DEPARTMENT of ENVIRONMENT and NATURAL RESOURCES
PMB 200
Joe Foss Building
523 E. Capitol
Pierre, SD 57501-3182

5-9-2012 Final draft 5/29/2012

Please consider this the final reply to letter dated 4/13/2012.

MP4 - A

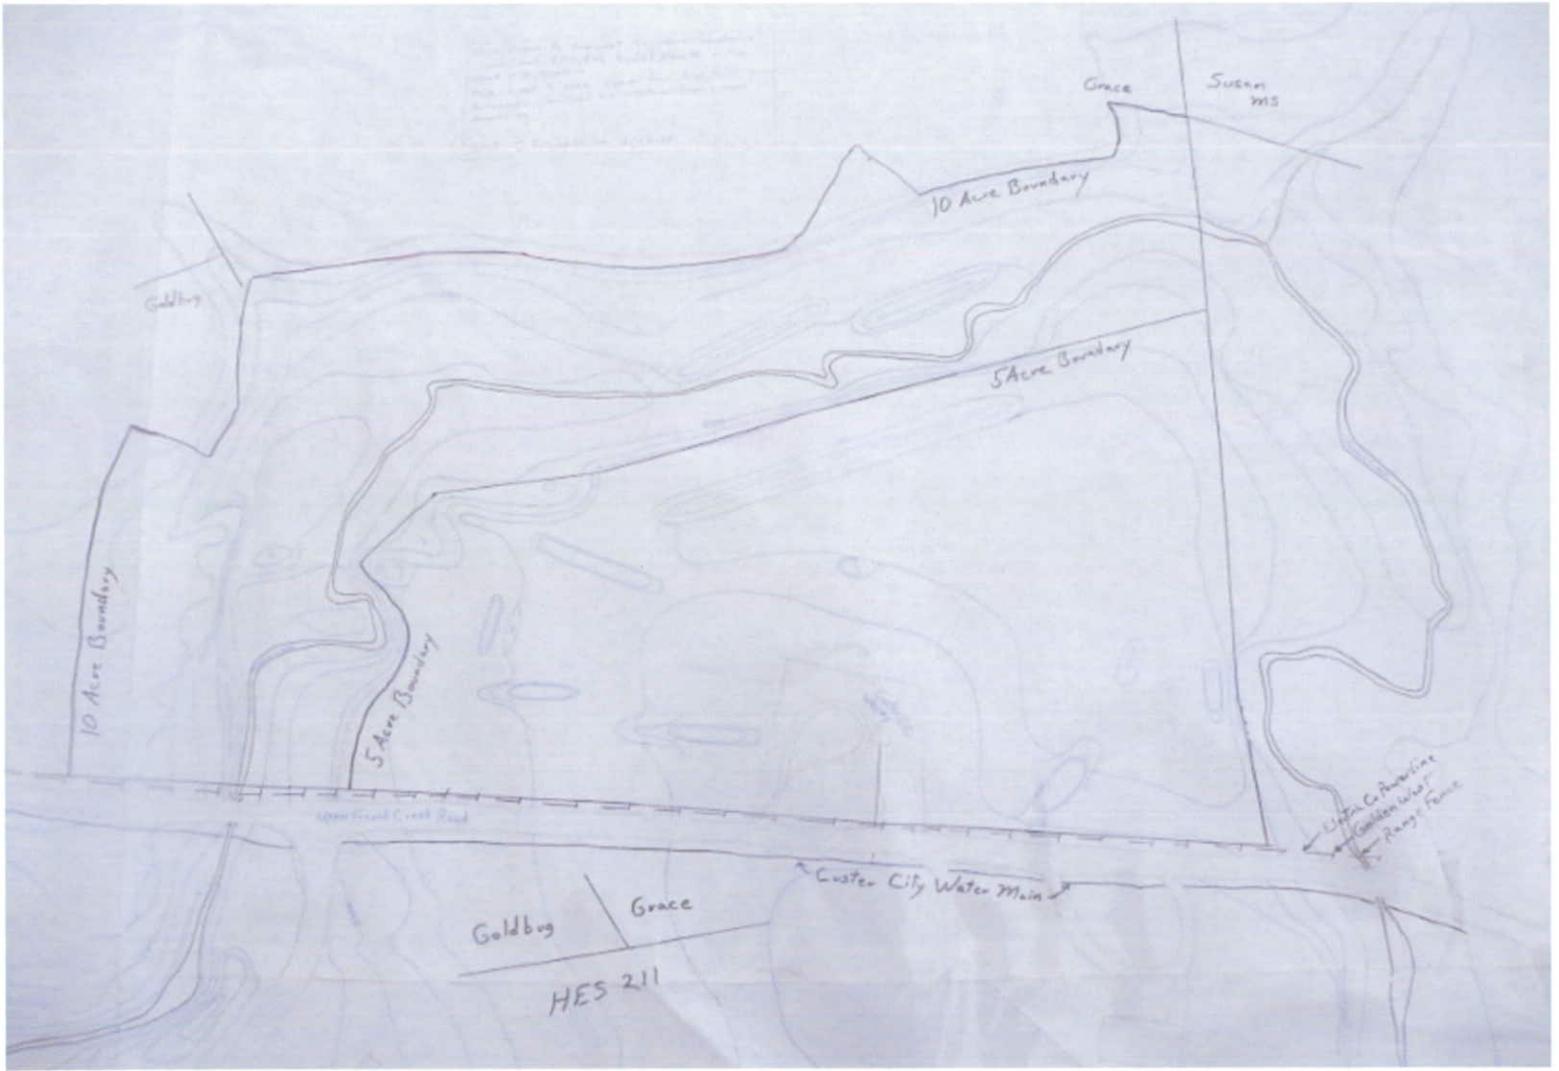
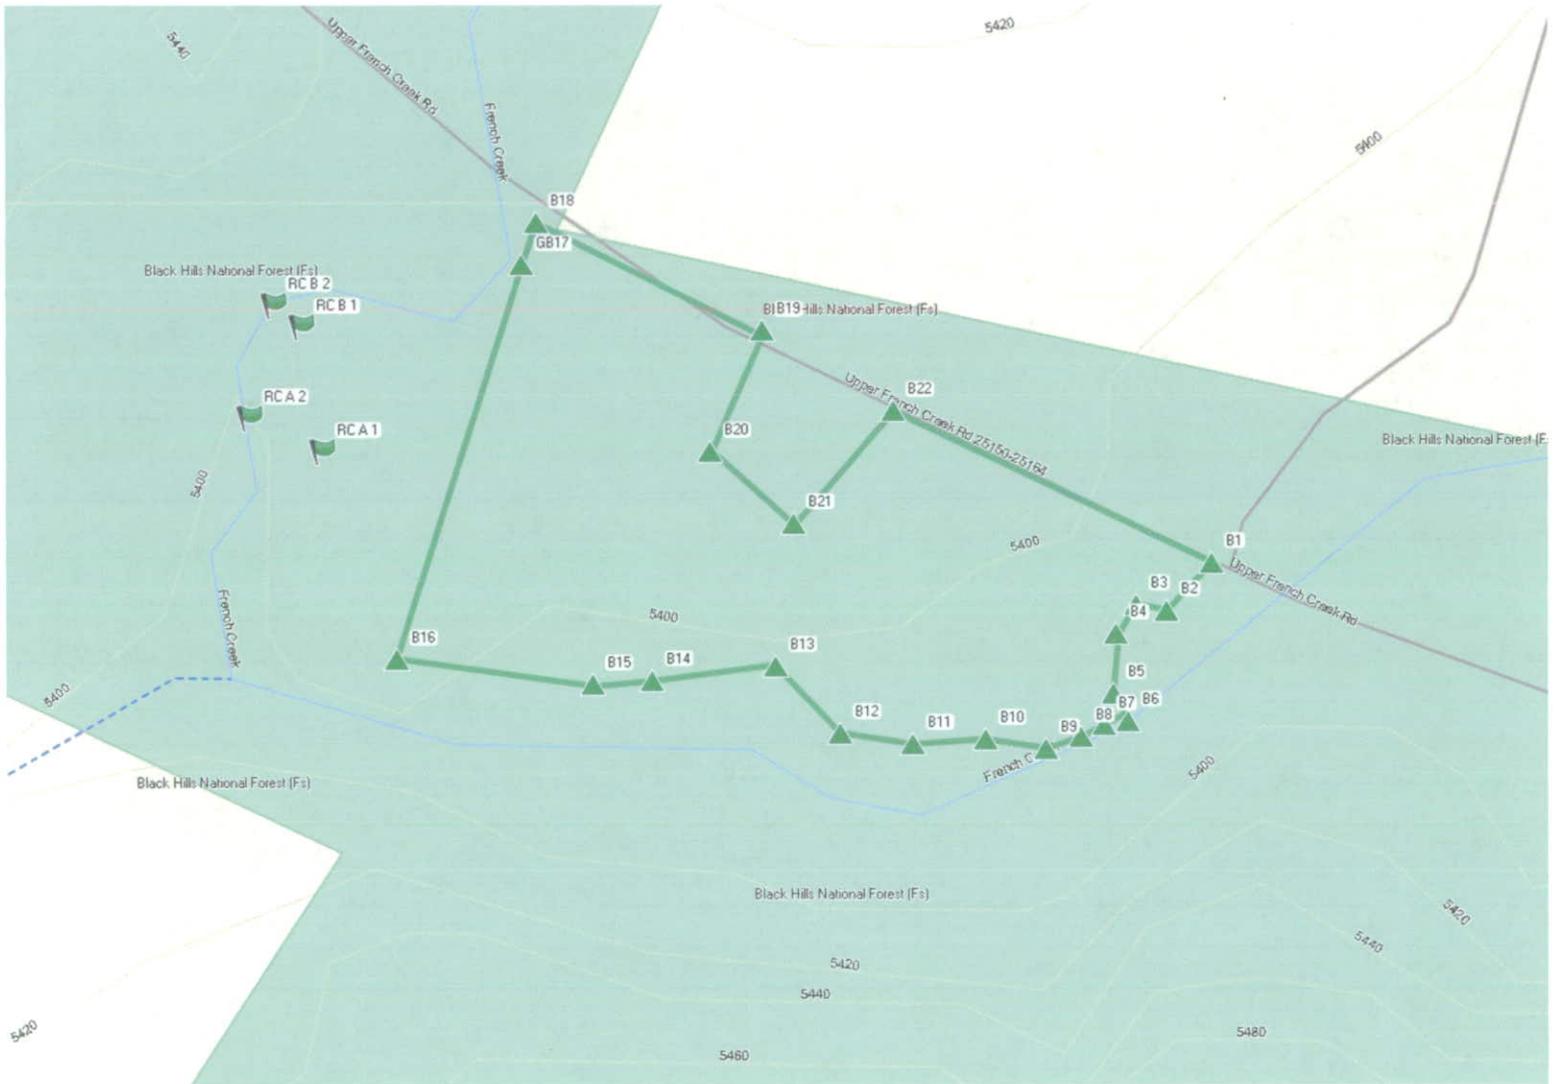
New maps are included to establish the permit boundary, MP 4-A, MP 4-B, MP 4-C. The ground is flagged, and the gps coordinates are provided. In establishing the boundary for phase 1 an effort is made to keep the edge on the highest elevation next to the creek. I noticed the "Map Source" and "Google Earth" do not show the creek in the exact position.

The positions were done using a Garmin E-Trex Legend C. The contraction indicated the accuracy to be 4 ft on most all of the points.

MP4 - B

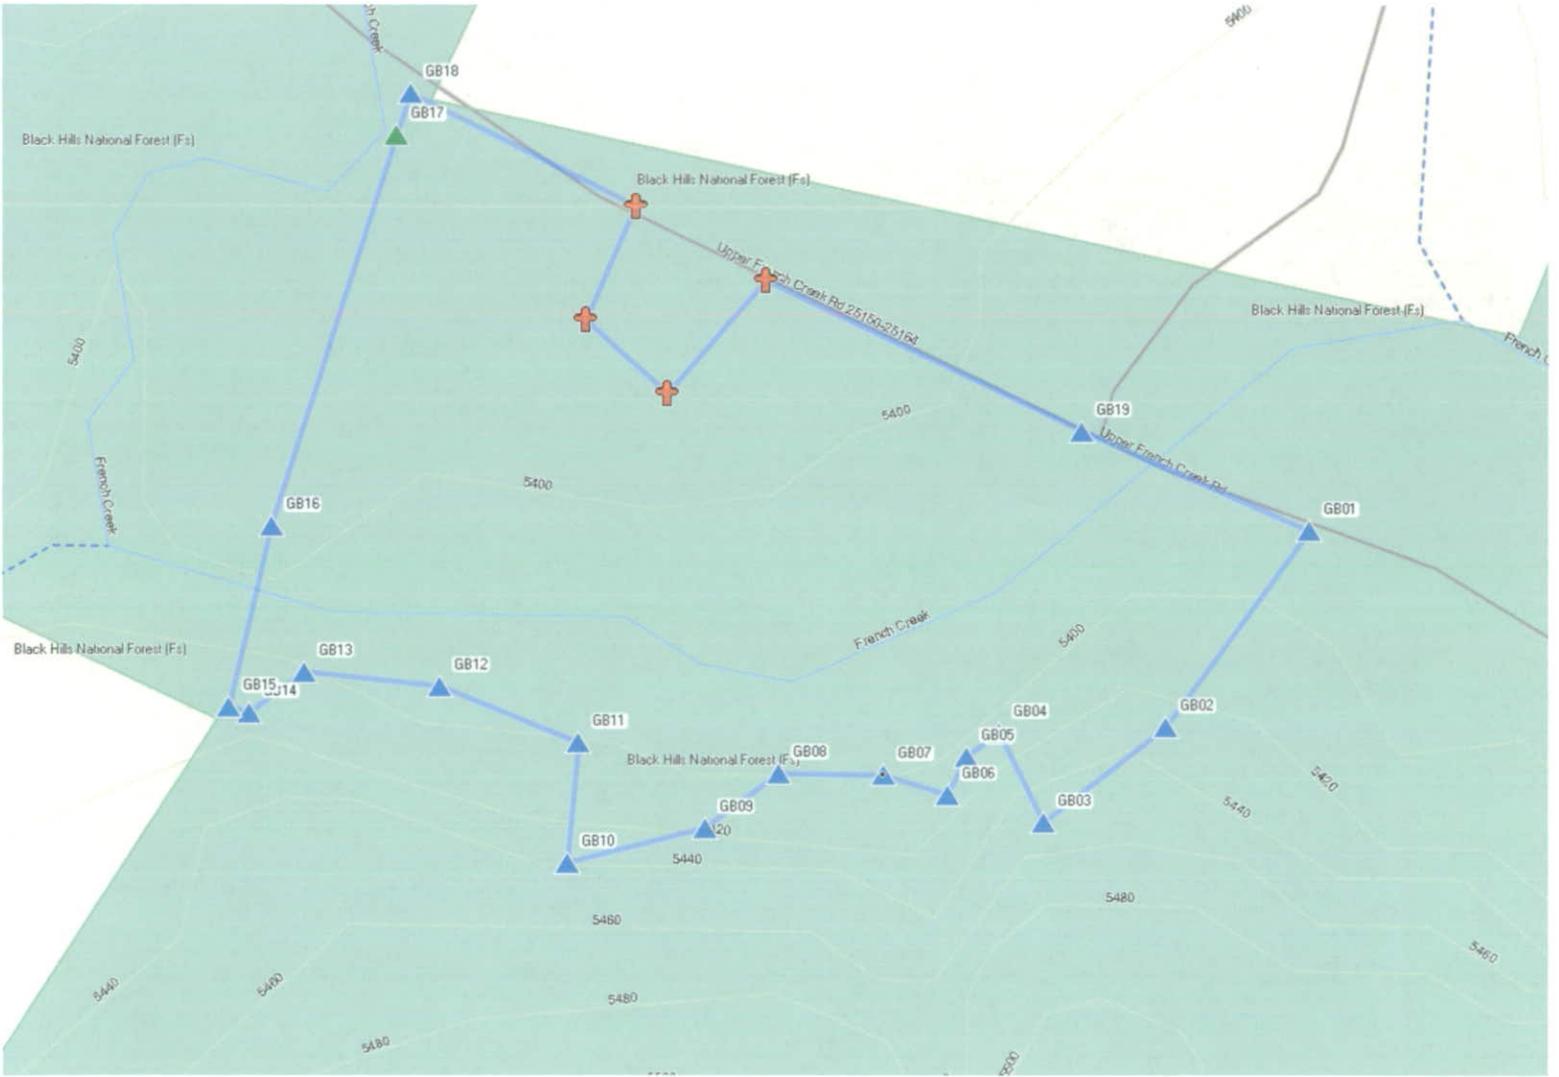
There are two sets of points on the maps, RCA and RCB. These points, 1 and 2 measure the creek channel across from one side to the other. They are provided to help determine the diversion channel width and depth, if and when needed.

MP # 12

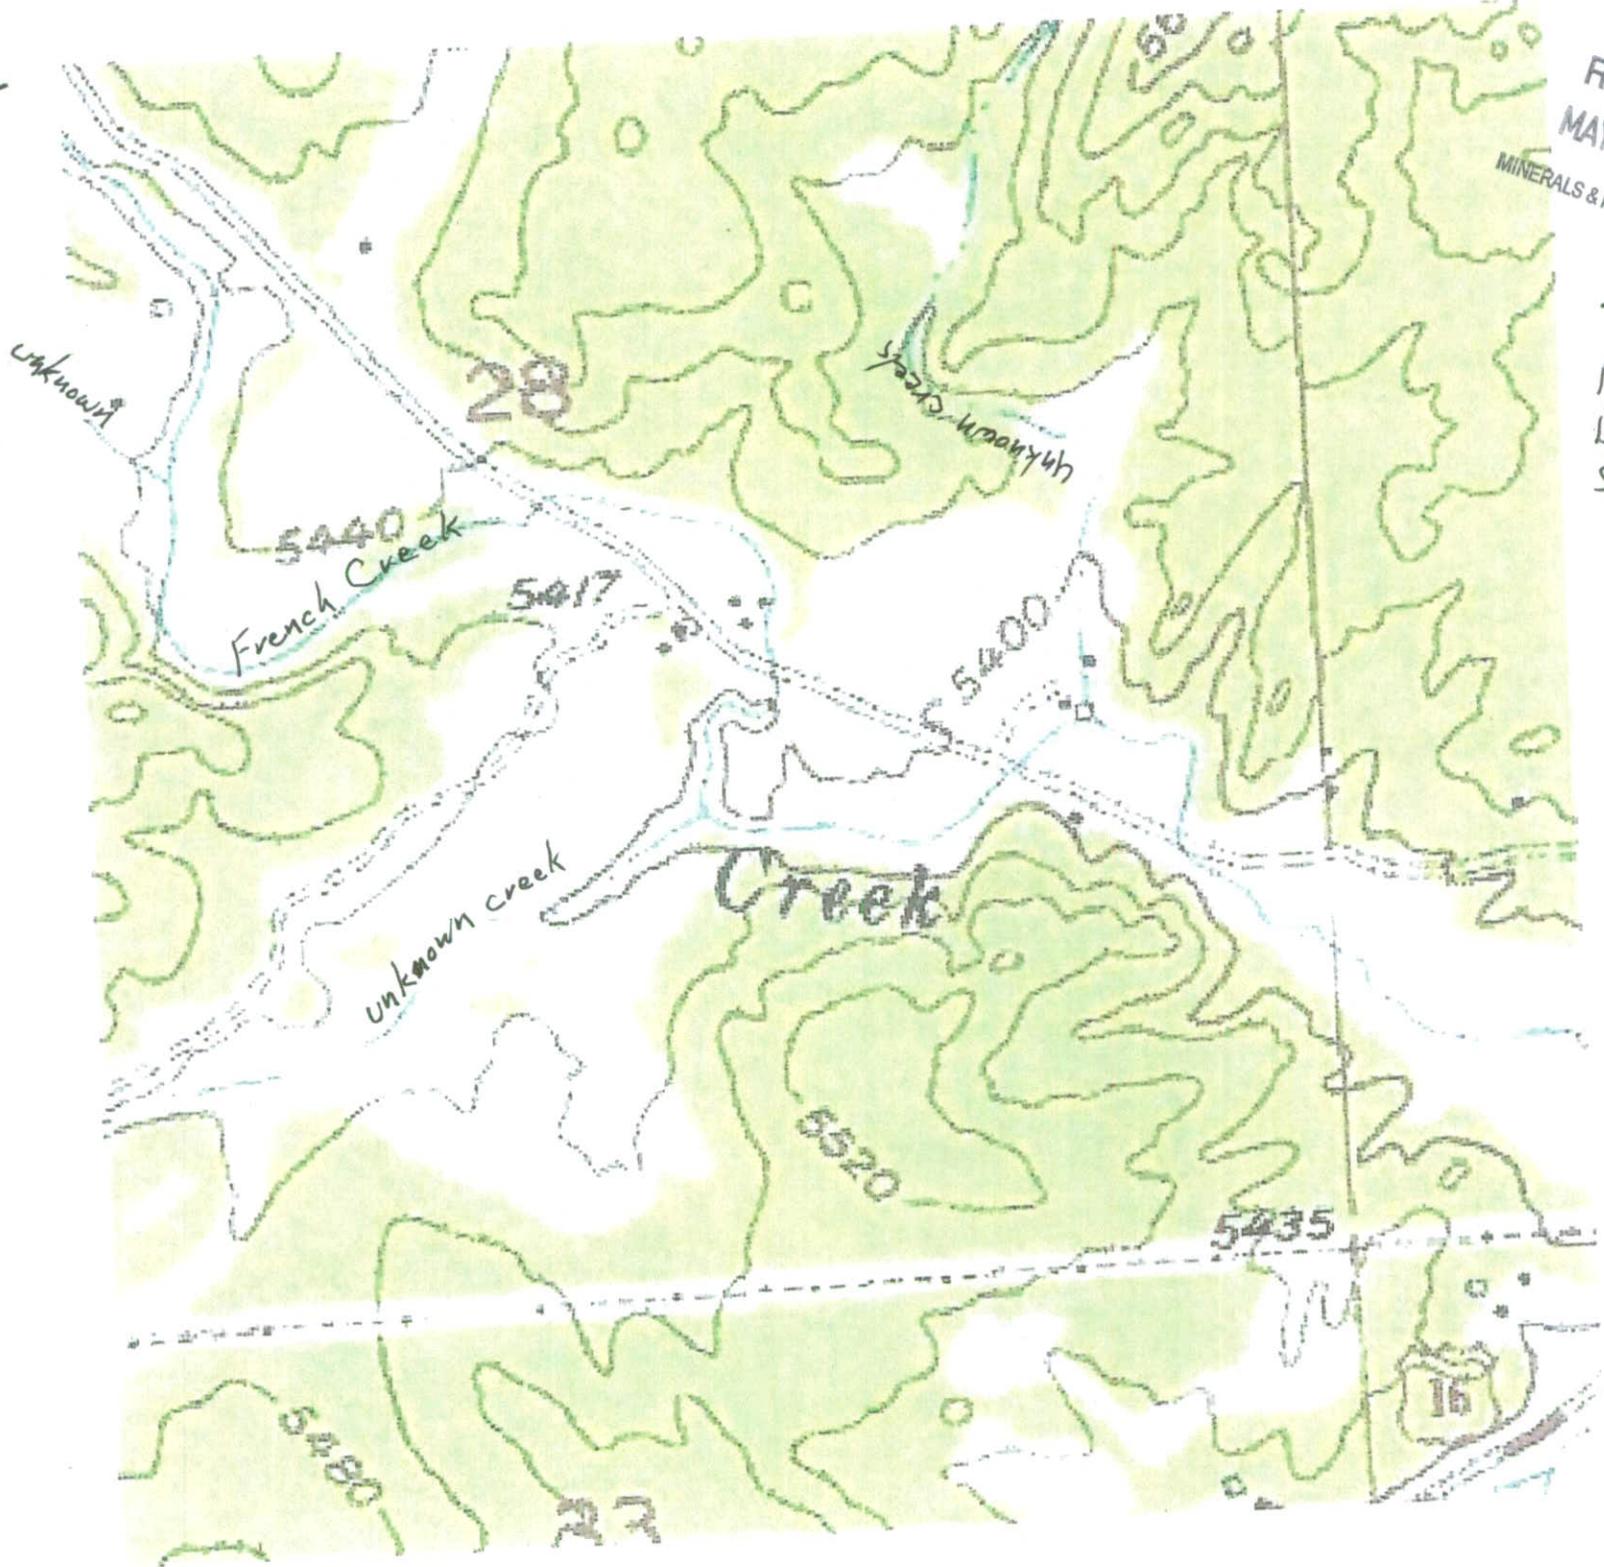
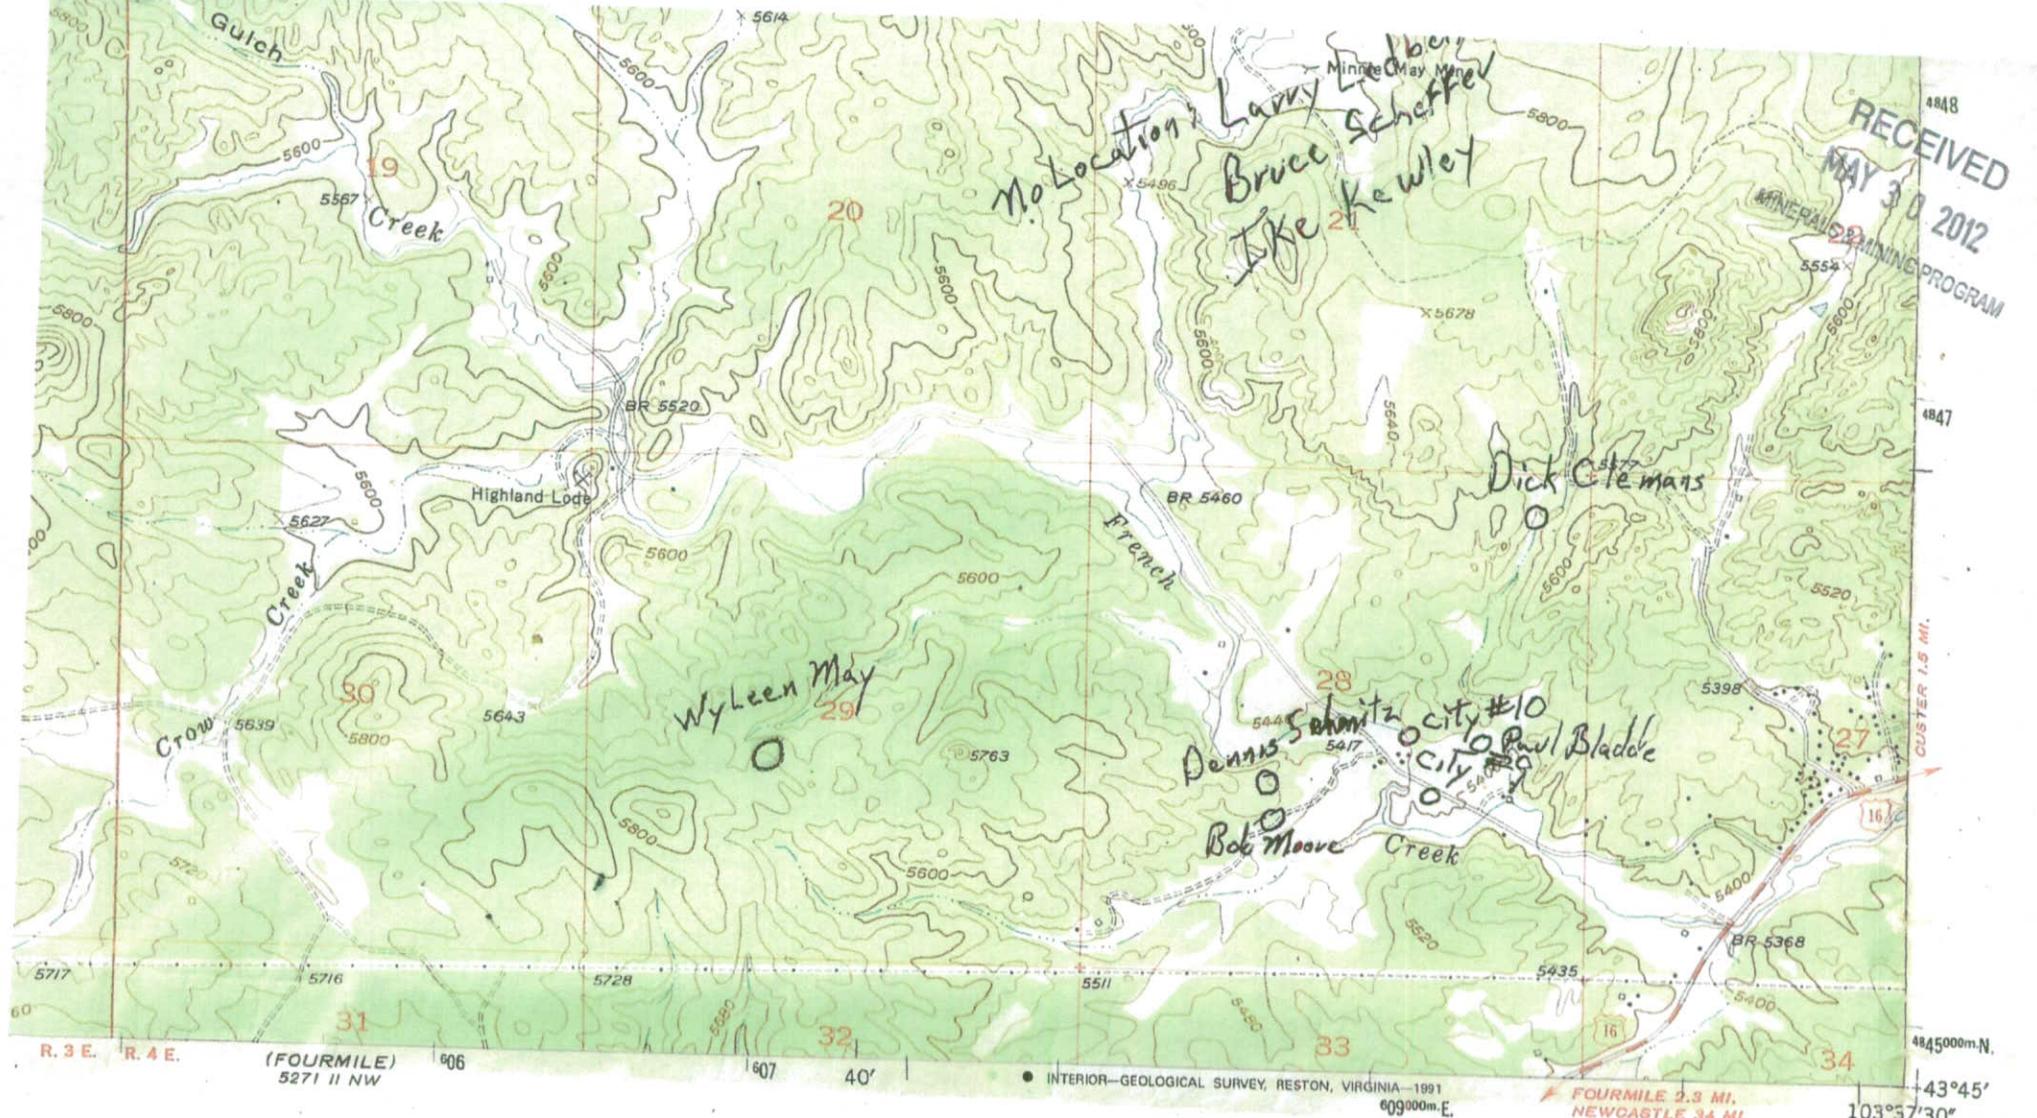
9. a. Please find submitted map. MP 2 Pages 1,2,3.
- b. Please find submitted map. MP 12
- c. Please find submitted map. MP 13
